Date: November 30, 2023
To: All Vendors
Subject: Addendum #2

**REFERENCE: B014-24 Re-Bid BPUB Downtown Wastewater Improvements-ARPA
Project 1**

Project:	Brownsville PUB – Downtown Wastewater Improvements ARPA Project 1 BPUB Bid No. B014-24	Addendum Date:	November 30, 2023
From:	Javier A. Esquivel, PE	Project No.:	BPUB2200025.01

ADDENDUM No. 2

SHEET
CA03

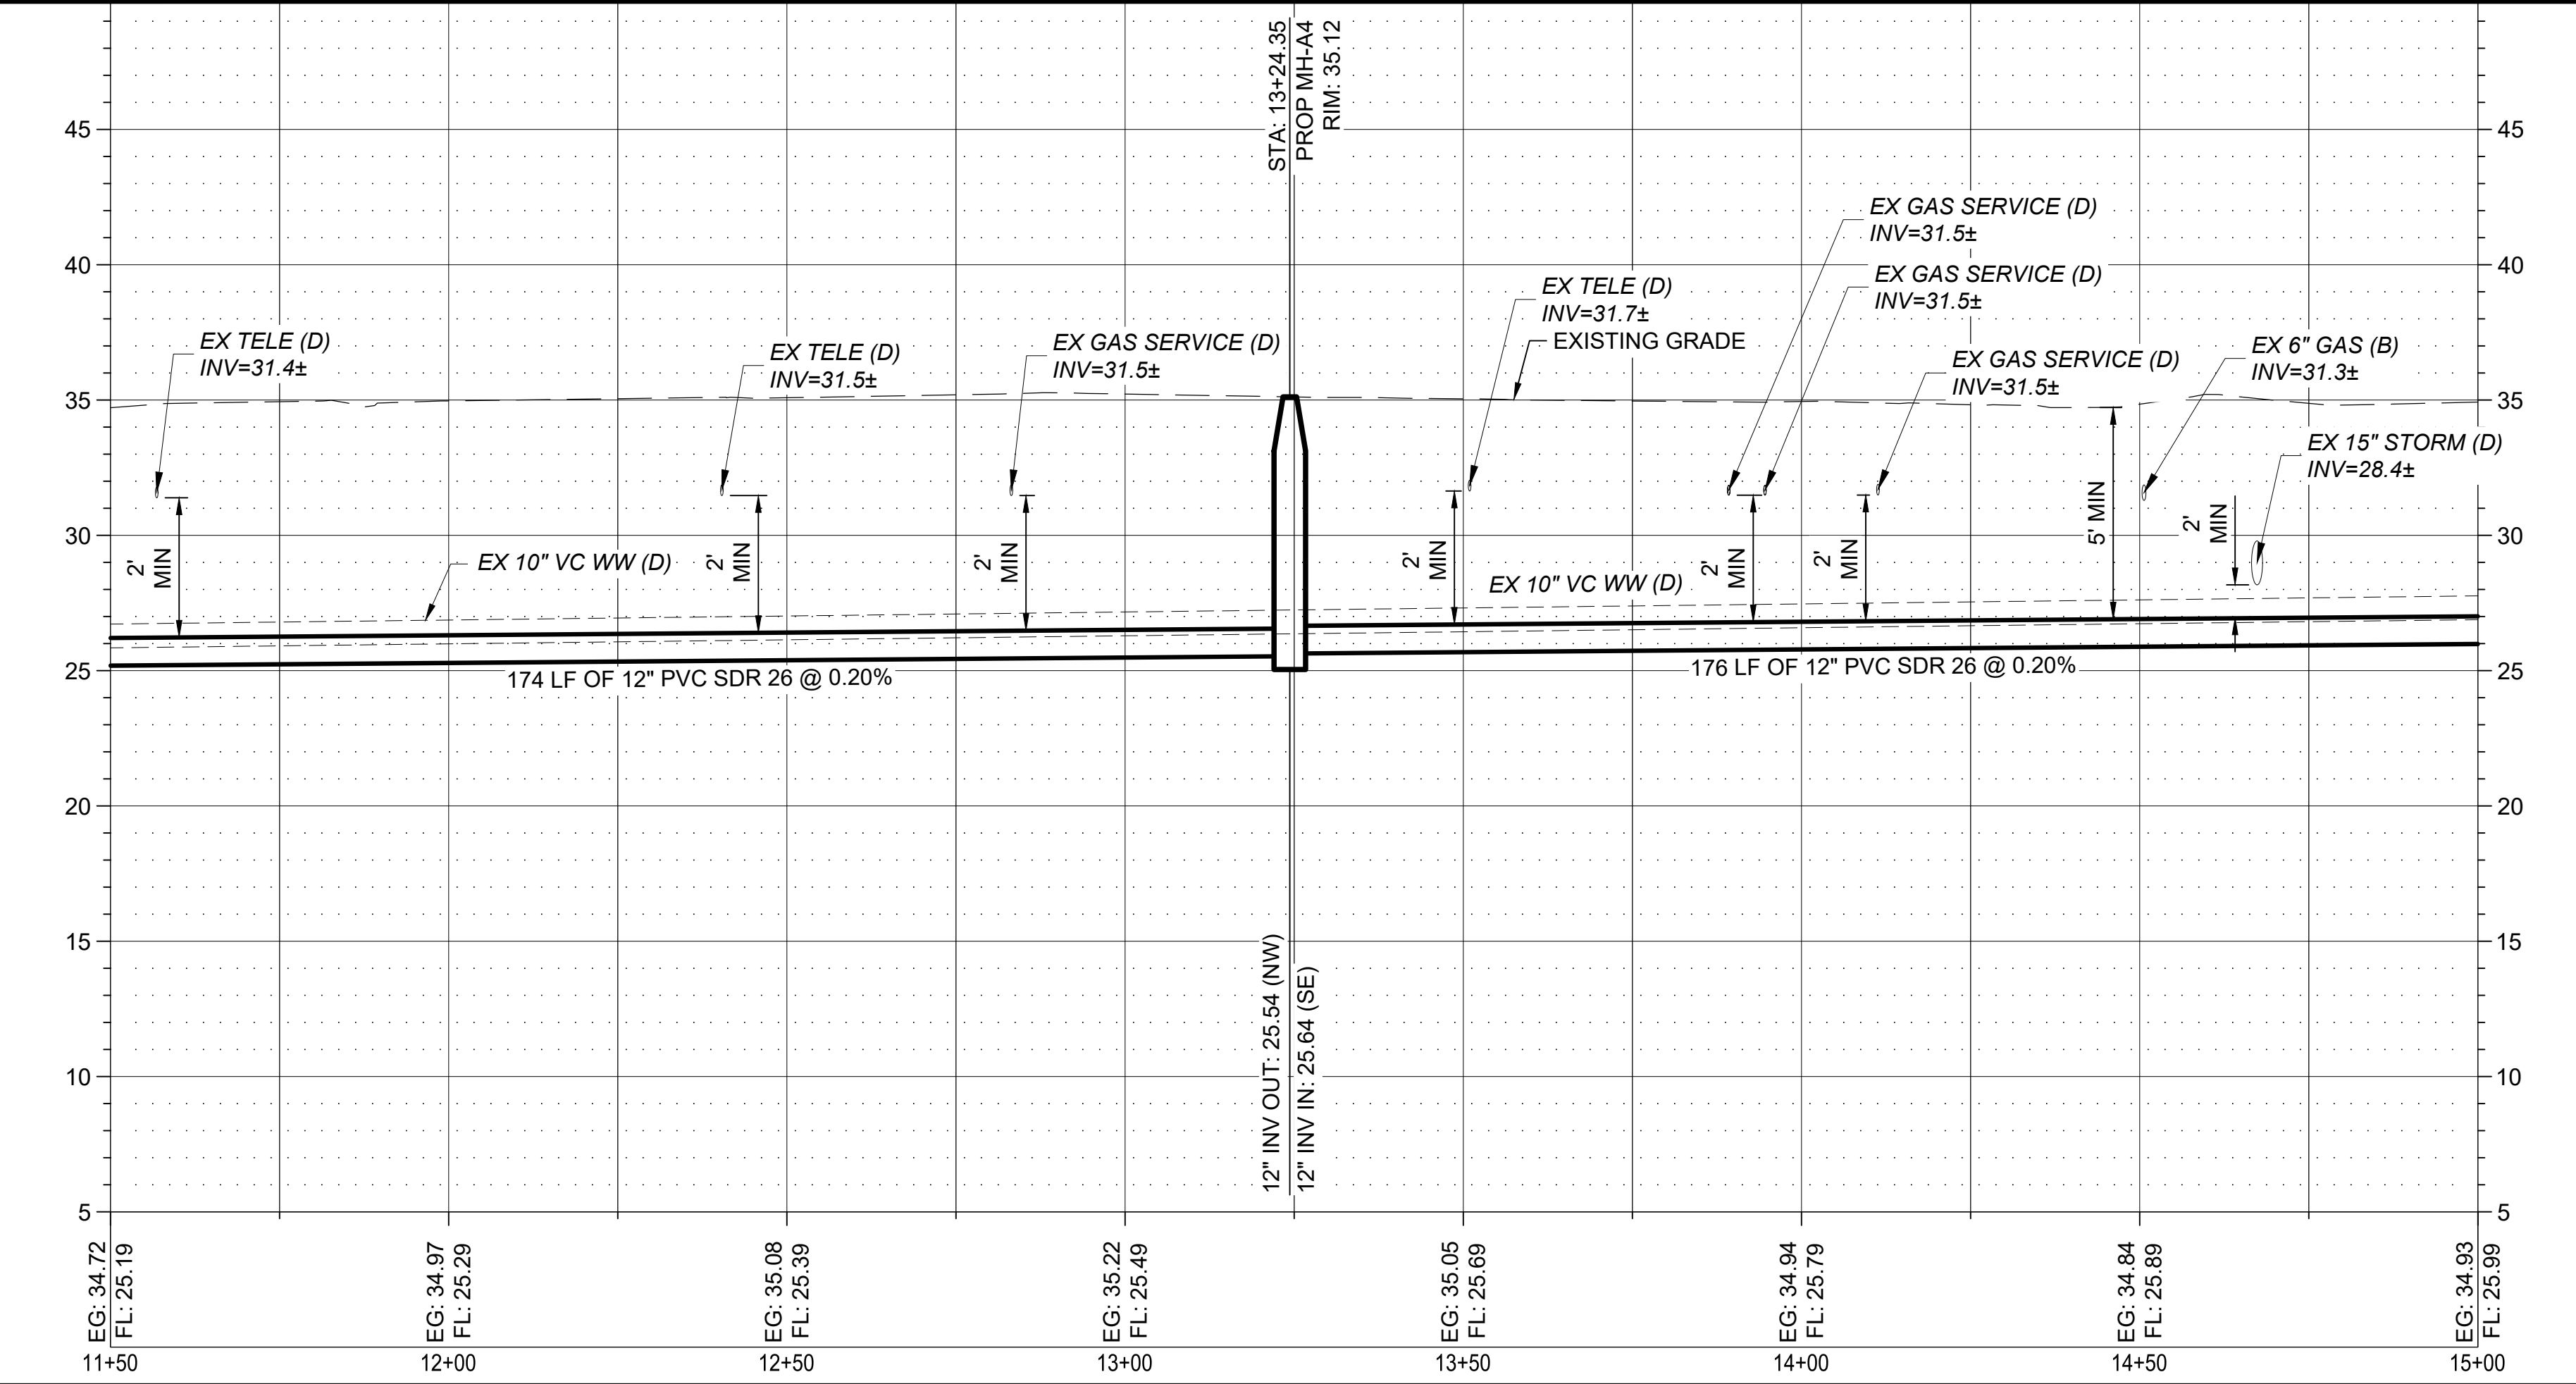
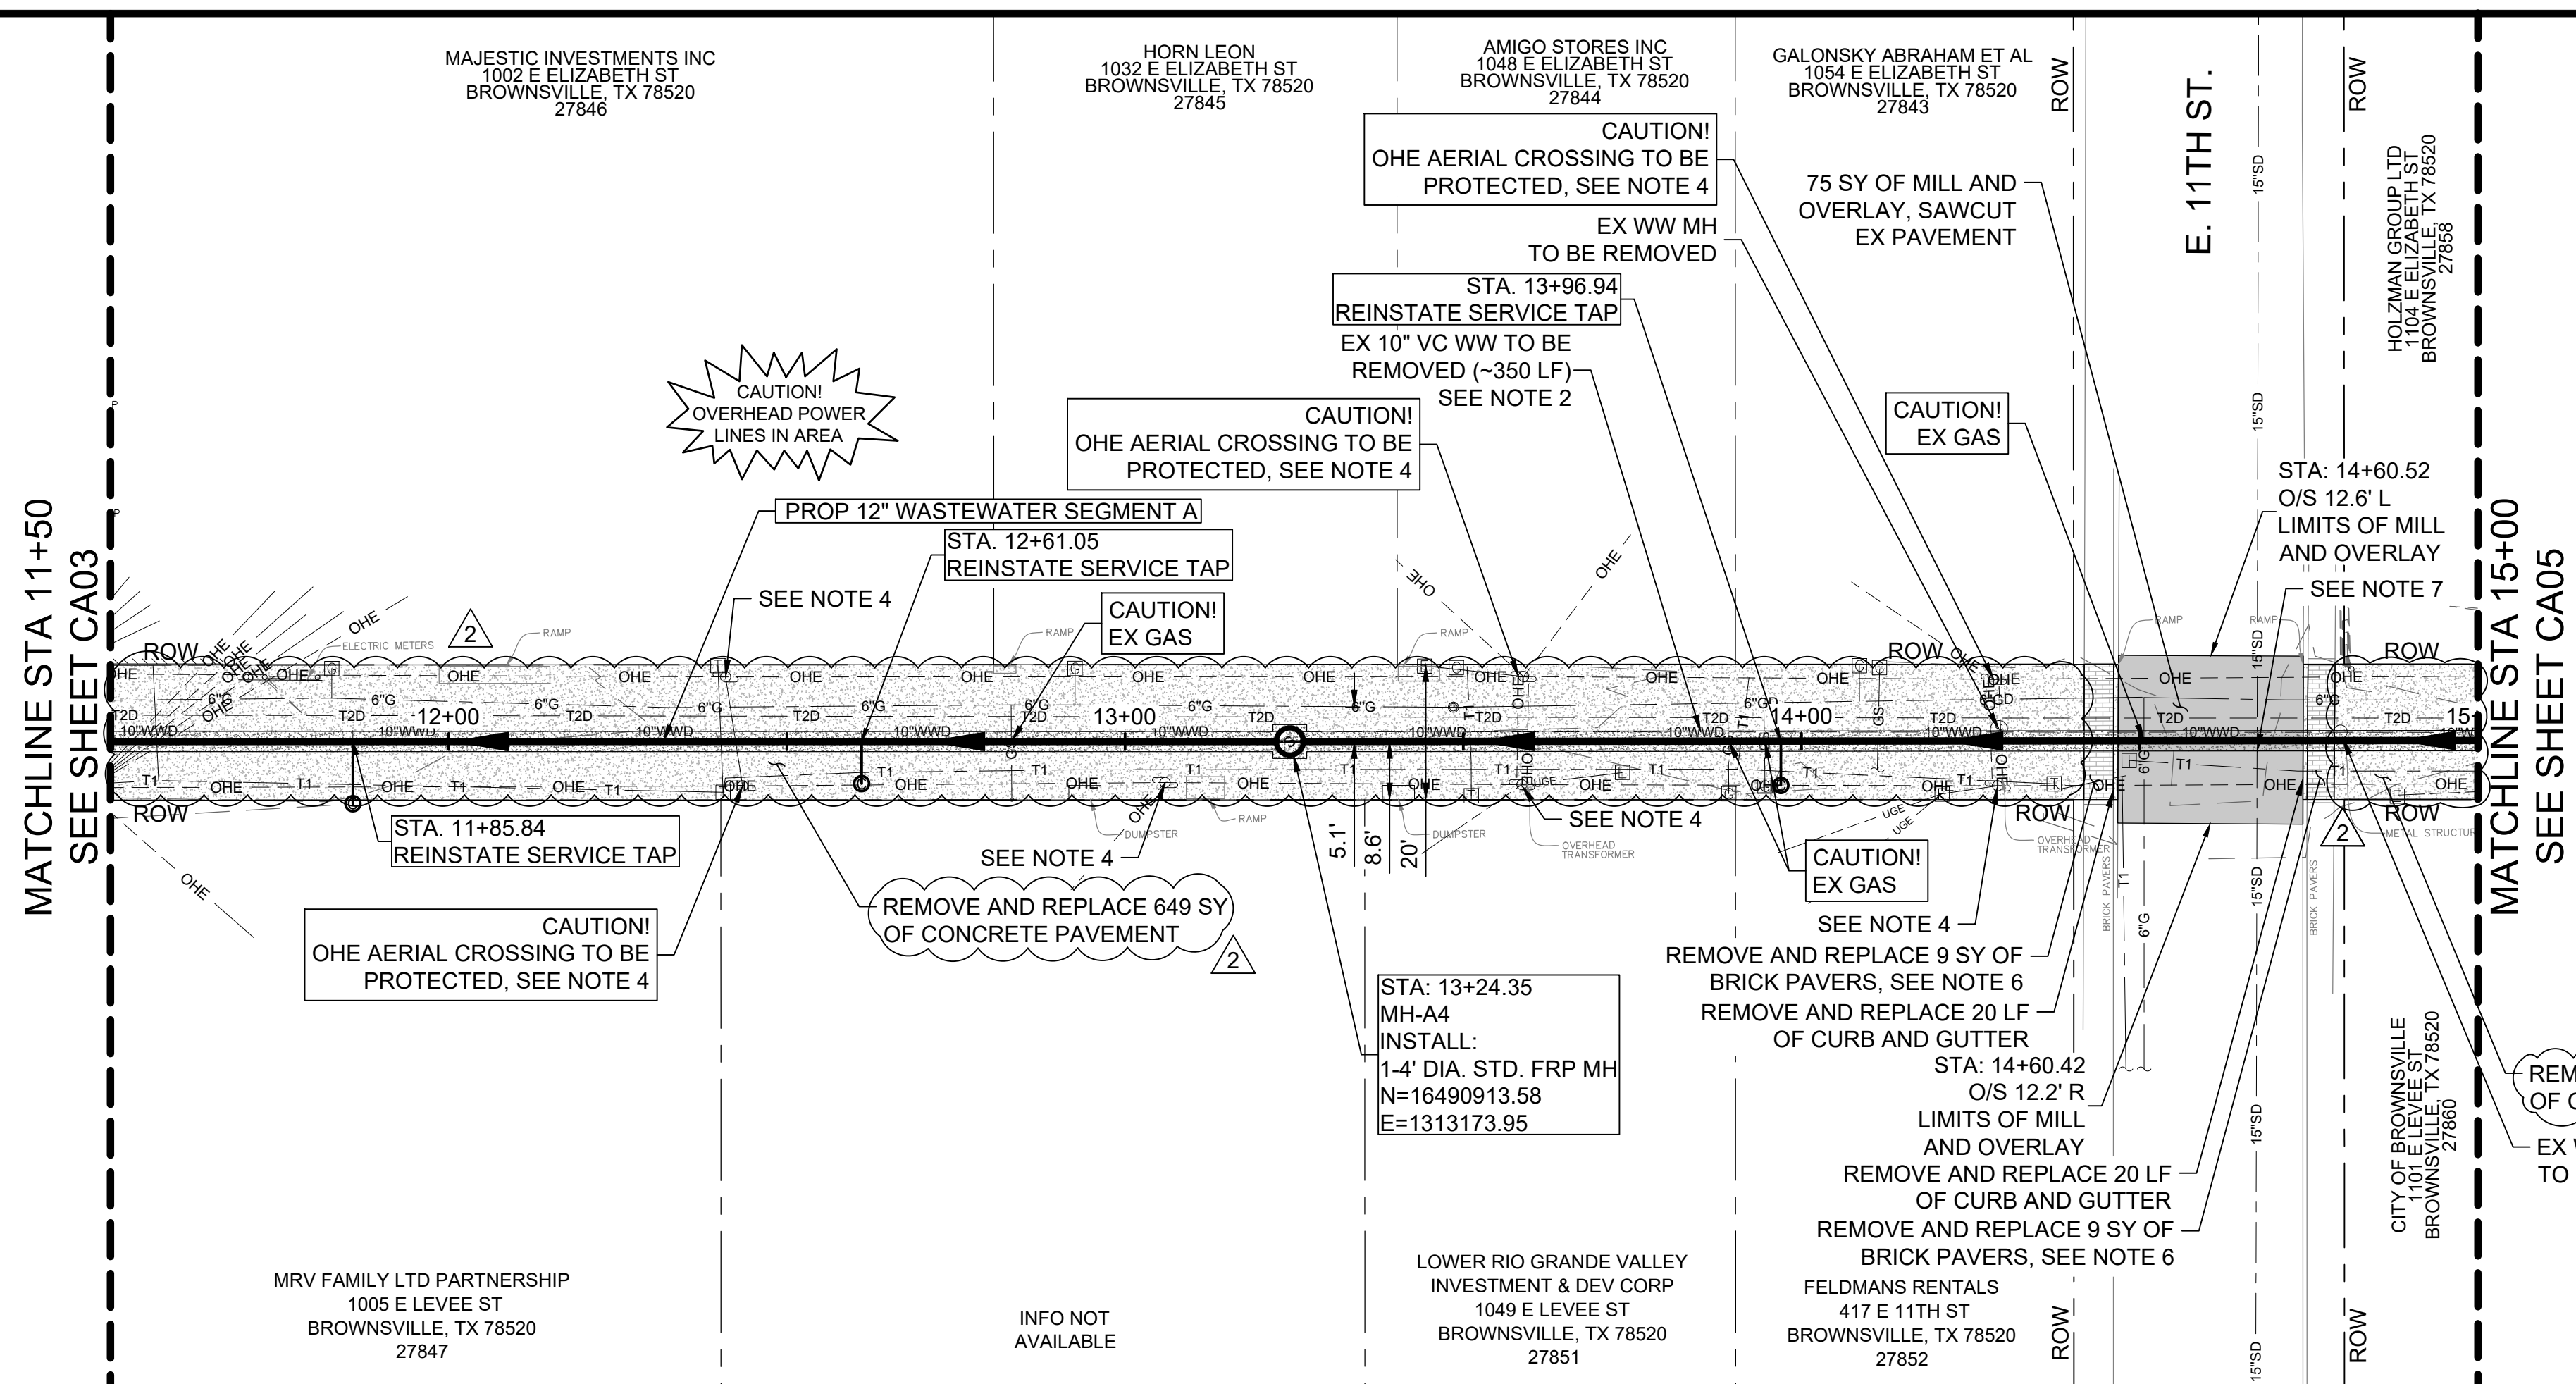
1. Revisions to Surface Restoration in the Alleys.
 - Segment A: Replace Mill and Overlay (2”) with full depth concrete asphalt pavement removal and replacement.
 - Segment B: Replace Mill and Overlay (2”) with full depth asphalt pavement removal and replacement.
 - Segment C: Replace Mill and Overlay (2”) with full depth asphalt pavement removal and replacement.

3. Plan Sheets: The following plan sheets were modified to update surface restorations CA02, CA03, CA04, CA05, CA06, CA07, CB01, CB02, CB03, CC02, CC03, CC04, and CC05.
